Modification Power Distribution Board to avoid booting problems (symptom: fan doesn't start or ev. screens black)

Vista 5 Distribution Board 1.949.810.00

D21m Frame 1.949.405.82 LED/PSII Board with Power Supplies

New Trackball wiring (USB)

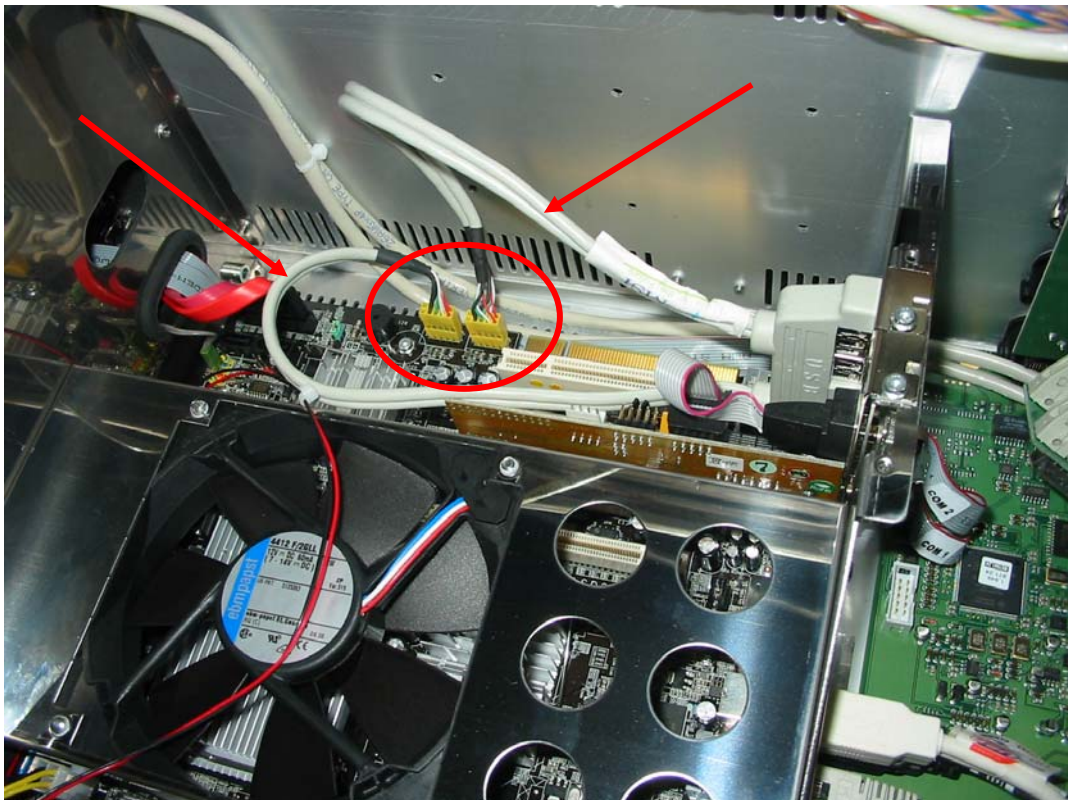
On the motherboard install the USB 2.0 cable, just behind the COM 1 and COM 2 connectors as shown in the picture below:

- Insert the lower (yellow) connector into the connector labelled USB 1 socket and the upper one into USB 2 socket, as seen on the picture above

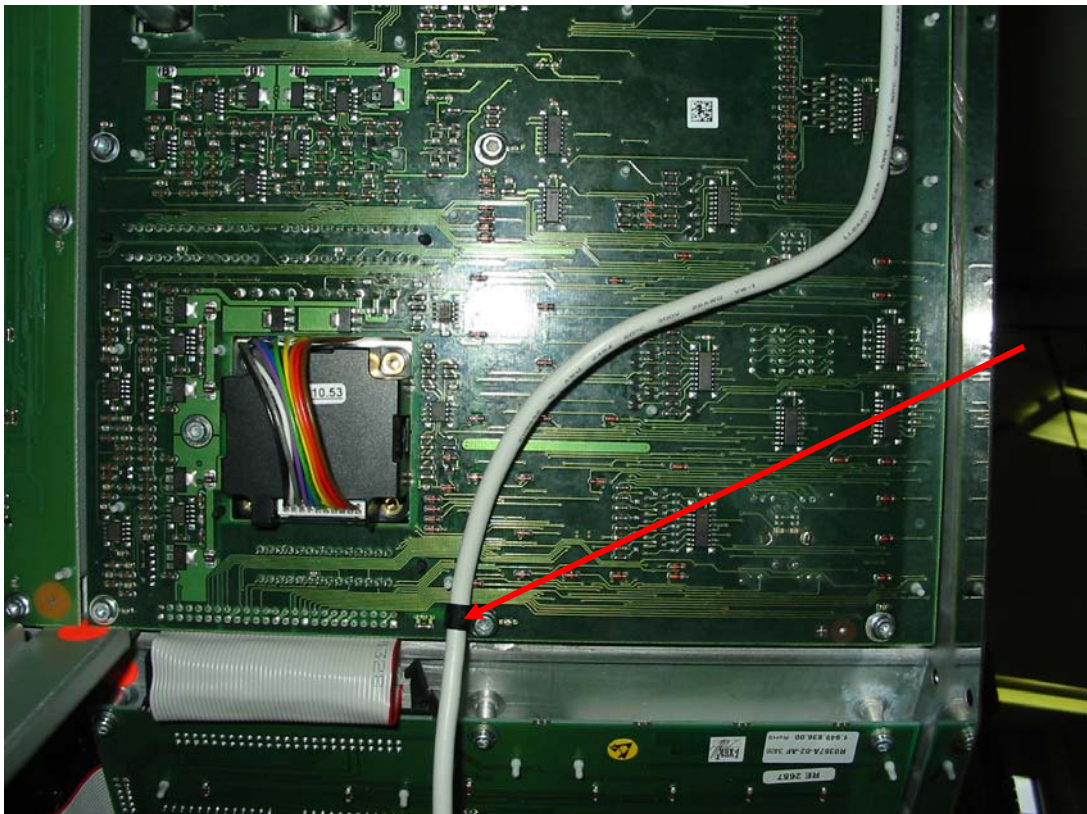
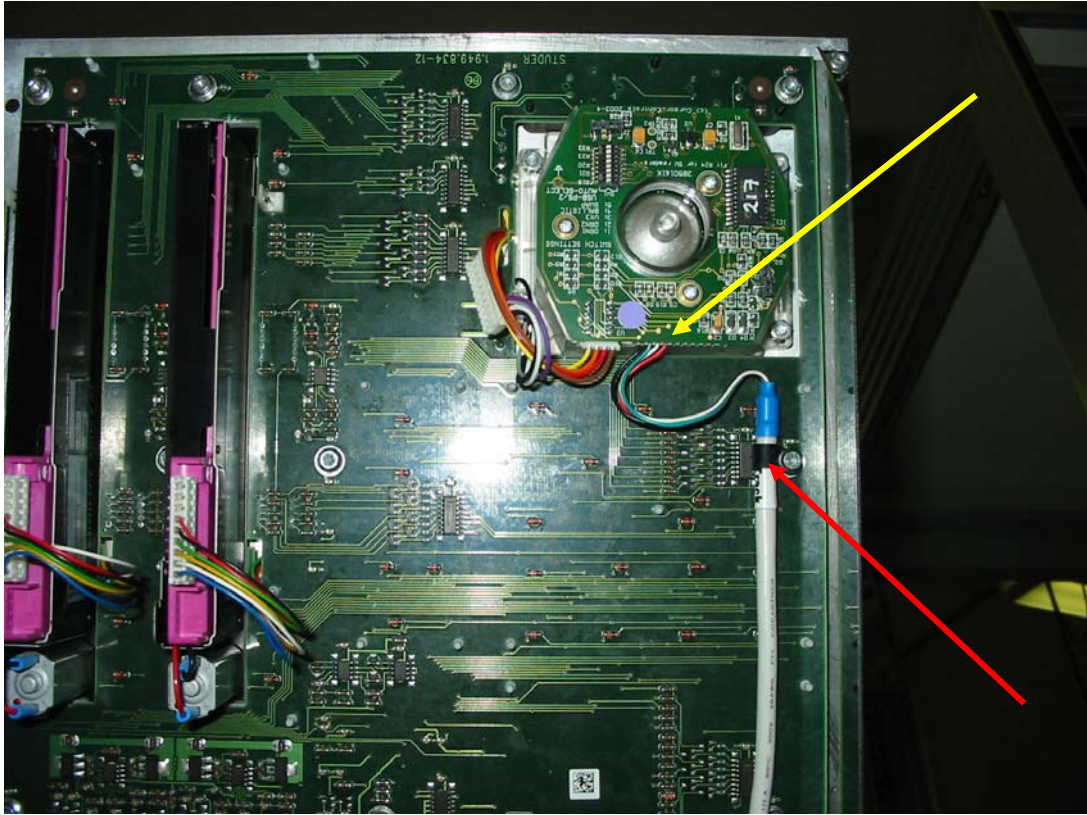
- Remove the connector from the track ball and install the trackball cable 89.20.1176 as shown on the pictures below (yellow arrow):
- Use the cable clamps to fasten the wire as seen in the pictures below (red arrow):
-

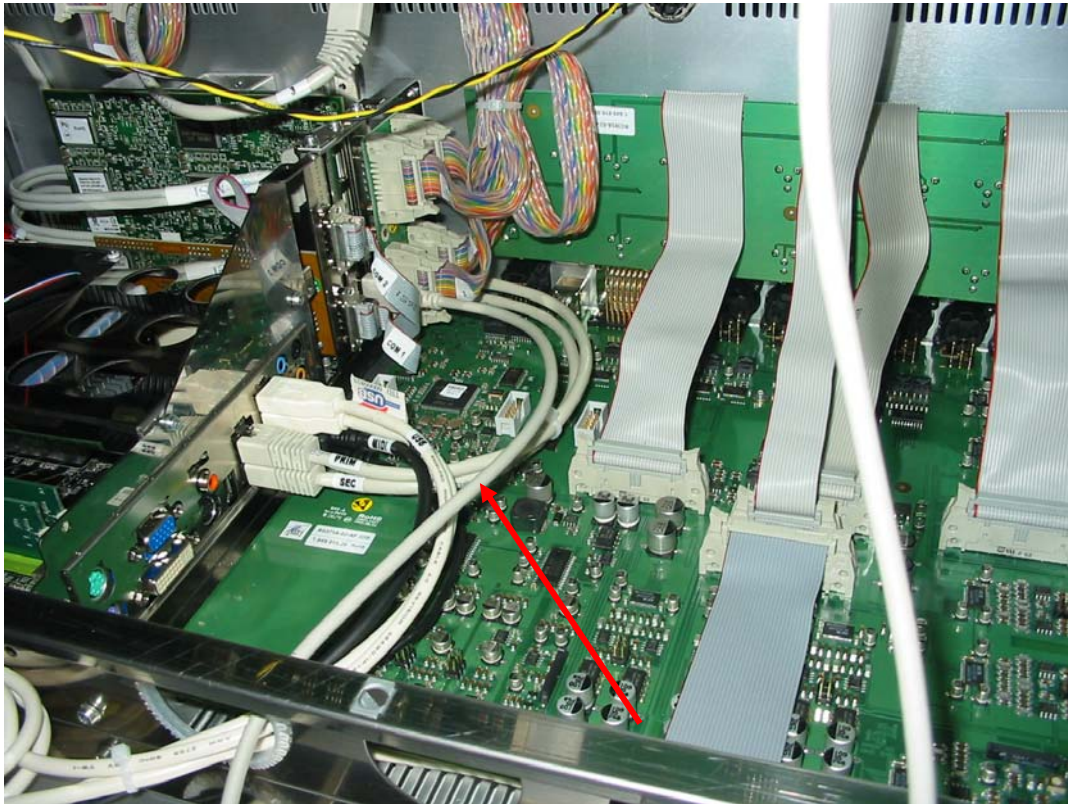
- Guide the cable through the edge protected Insert the USB plug into the lowest USB socket as shown in the picture blow . See red arrow

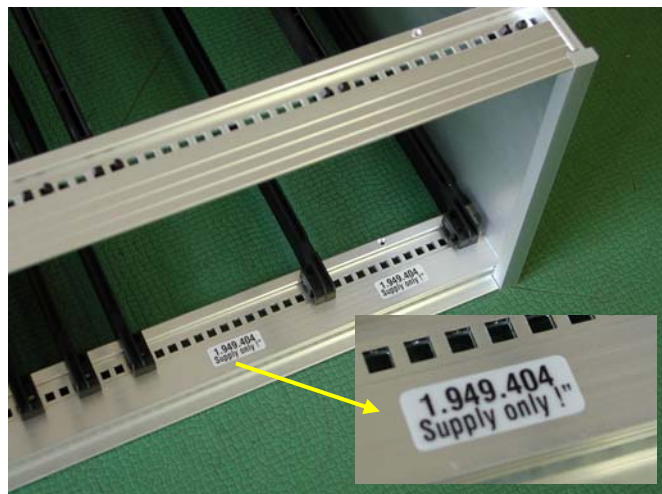
1.949.405.83 new type with
1.949.402.81 LED/PSII board
with warning label as indicated at right.

Note : When replacing a LED/PSII board, please make sure that the corresponding warning label in the rack is present. Spare/Replacement LED/PSII boards will be shipped with instructions and labels.

Modification 1.949.403.00 to revision "81"
(making 403 supplies ready for new D21 Racks)

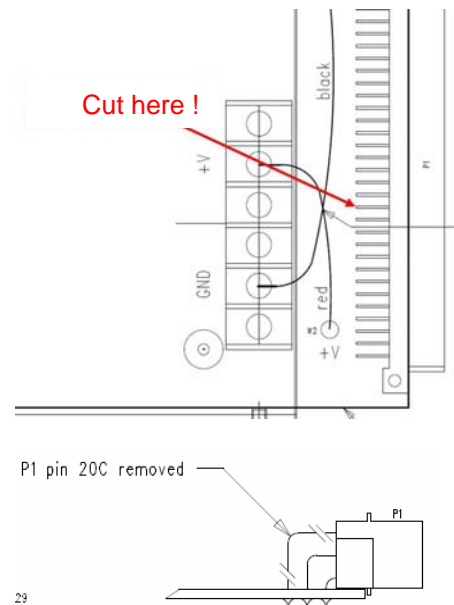
- Cut Pin 20C of connector P1

- inserting 403 spares into a new D21m frame
- replacing a LED/PSII Board 1.949.402.00 with an index 81 one.!

Modification 1.949.402.00 LED/PSII Board
for 89.20.1167 cables (15 pin 1:1)

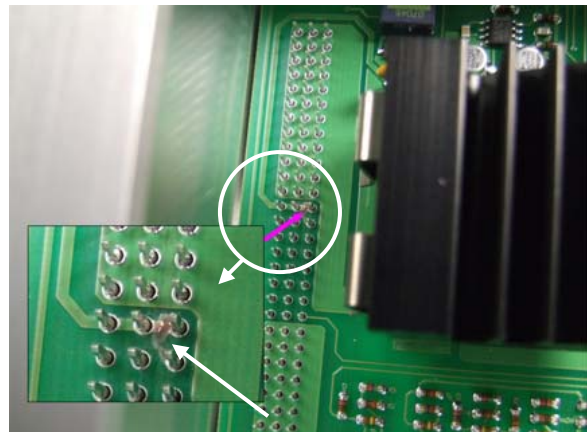
Cut the track as indicated at right.

This modification is not required when using the modified fan cables (without pin 13 wired, Studer made, light grey cable) - all system shipped from Studer were correctly equipped.

Replacing the distribution Board 1.949.810.00 with the new version with revision index .81, or .82:

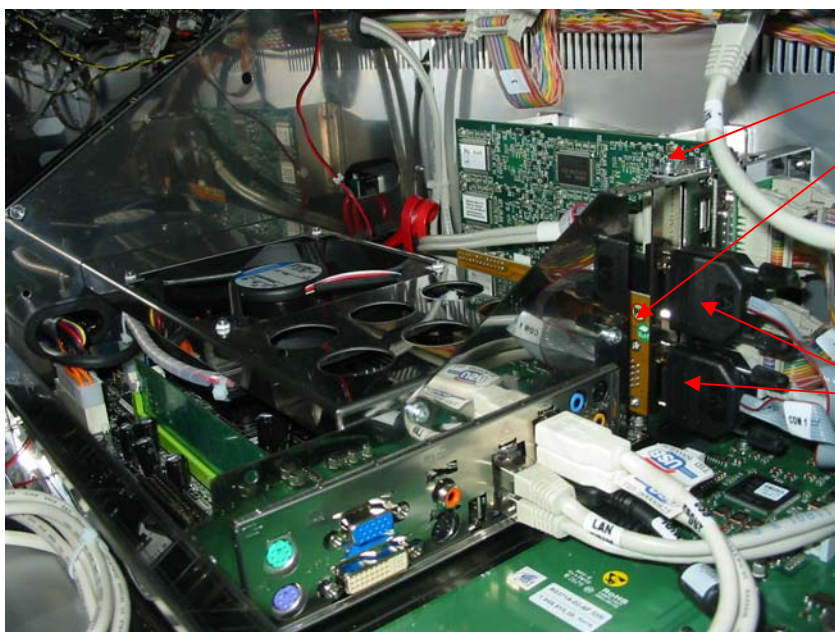
Open left hand bay (Input fader bay)

Unscrew the 2 security 5mm hex bolts of each COM port (COM1 and COM2) at the rear of the desk.

Remove the 4 fastening screws with a 2.5 mm Allenkey

Unplug all the connectors on the board and carefully lift out the Distribution Board

Put in the new Distribution Board 1.949.810.81, resp. 1.949.810.82 and fasten first the 2 COM port connectors at the rear of the desk.

Fasten the PCB with the 4 fastening screws (2.5mm)

Reinsert all the connectors (except the COM1 and COM2 port) as shown on the attached layout

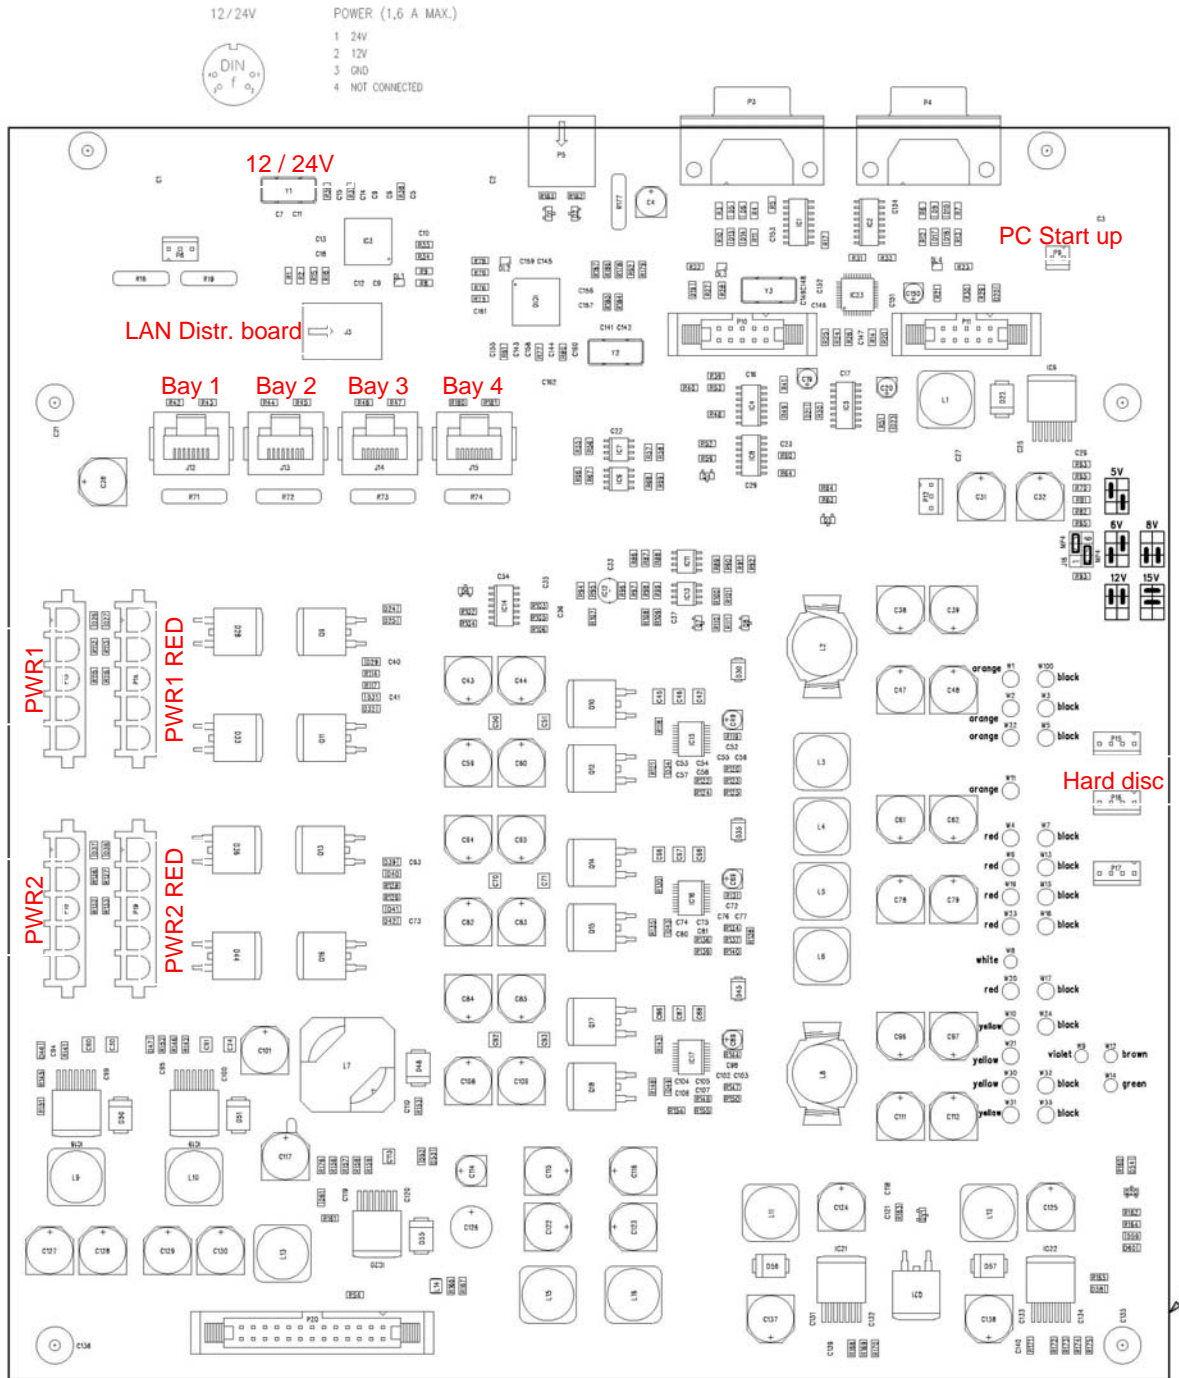
Open the right hand bay as well and remove the COM1 and COM2 cables, see picture below

Remove the 2S Serial RS-232 High Speed PCI card (it is no longer used), see picture below

Unscrew fastening screw to remove the RS 232 High Speed PCI card

Remove COM1 and COM2 plugs and wiring

D21m MADI HD Card 1.949.411.23 / 1.949.413.22

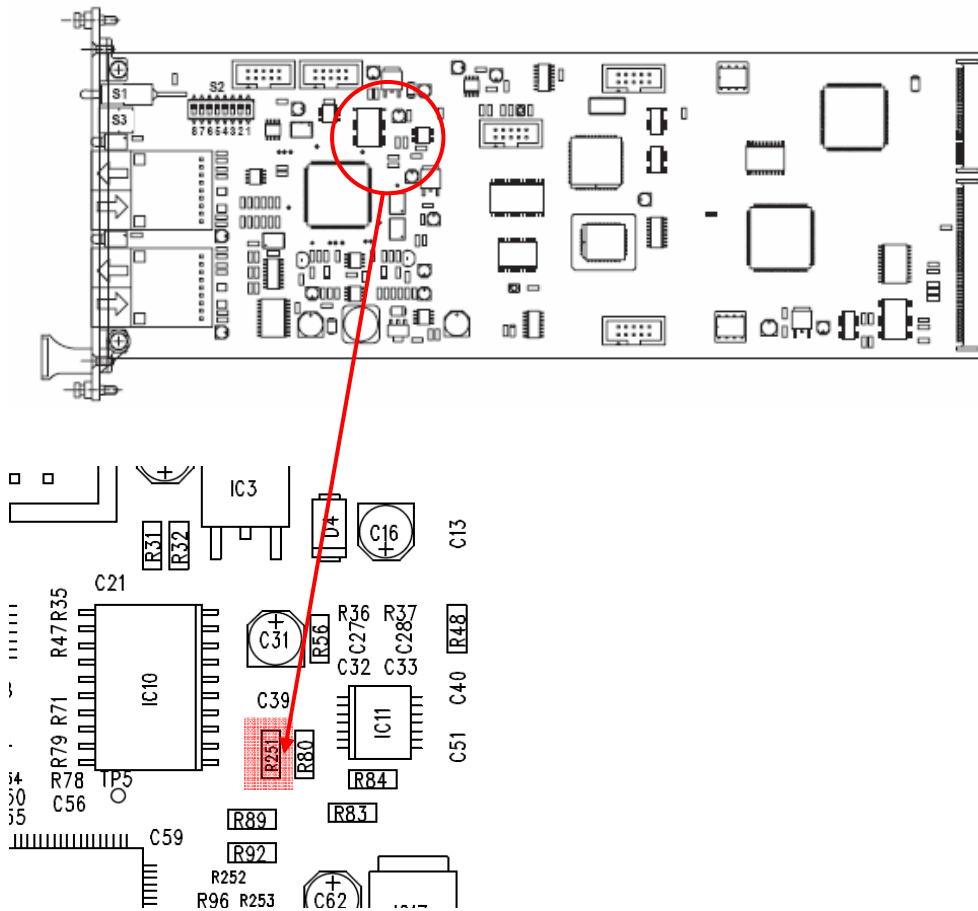
Problem : When more than 48 different audio signals are present on the MADI input, there was an increased jitter of the FS SYS signal measured on some cards. This caused the D21m stagebox not to work properly anymore (clicks on output channels)

Solution : The problem is fixed with an improved layout in the successor boards 1.949.411.24 (multimode) and 1.949.413.23 (singlemode)

Current boards which show the problem can be fixed by replacing R251 (33 ohms, Minimelf type) with 82 ohms (Studer order no 57.60.1820).

D21m Frame 1.949.405 - MicLine Cards and Grounding

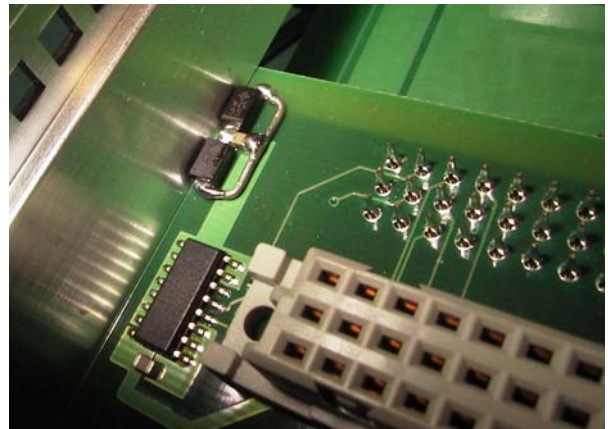
When using Mic/line cards with phantom power in a correctly wired system, the microphone is isolated to the D21m CHASSIS. The circuit inside the microphone takes its supply from Pins 2 and 3 (+ and -) for the positive reference and Pin 1 (GND) for the negative reference.

If a patch bay is implemented, GND (pin 1 on XLR connector) of each microphone input should be connected to its corresponding GND pin but not to CHASSIS. If CHASSIS instead of GND is used as negative reference for a microphone, it can occur that the GND net of the D21m is pulled towards -48V. This causes the HD-Link receivers on the HD card not to work correctly or to be damaged, depending on the type and number of microphones connected.

Solution : To protect the HD-Link inputs, antiparallel diodes between GND and CHASSIS will be implemented on future versions of the D21m backplane.

Connector quick-fix:

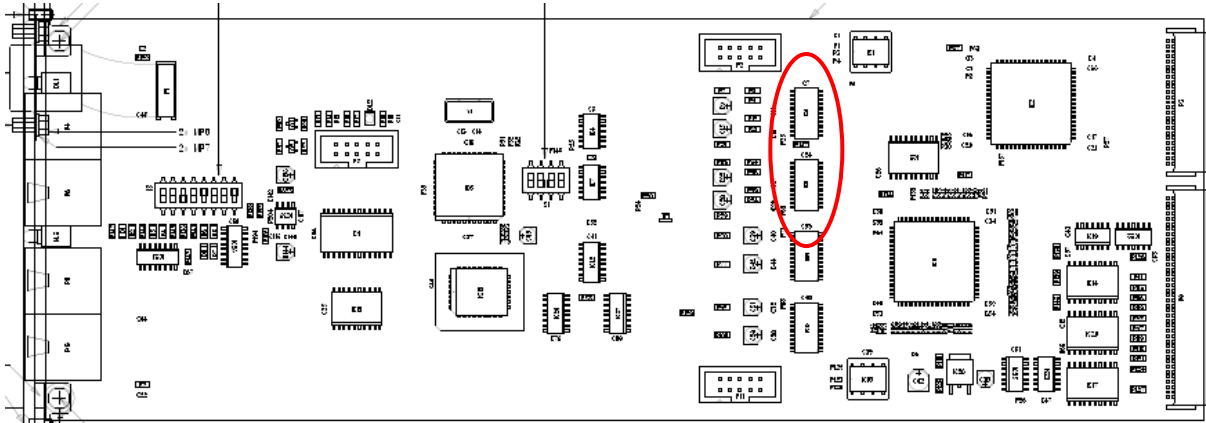
Solder antiparallel diodes
S1B (50.60.8003)
over C15 (a 15mm wire is optimal).

In cases where the frame cannot easily be removed, the diodes can be introduced through a connector which is plugged into the fan/status connector at one of the power supplies :

Use antiparallel diodes 1N4001
(50.04.0122) to connect the
connector shield :
in DB15 variants 1.949.404.00
with Pins 3 and 7 (see at right)

or in DB9 variants 1.949.403.00.
with Pin 8

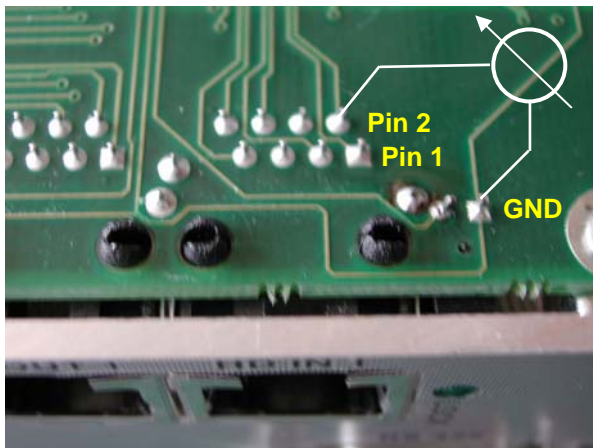
Analysis : If card inputs of a HD card 1.949.415 are damaged, it's typically the input stage of the LVDS receiver DS90CR216 (IC8, IC3 for IN1, IN2). As a result the input does no longer lock to an incoming signal (Lock LED stays dark), or the HD link becomes unreliable (see measurement below for verification)

Defect receivers typically show different input impedance when measured to ground reference. Good inputs have high impedance (MOhm range), defect ones show often < 1kOhm (see example with measurement points for input 0 below) :
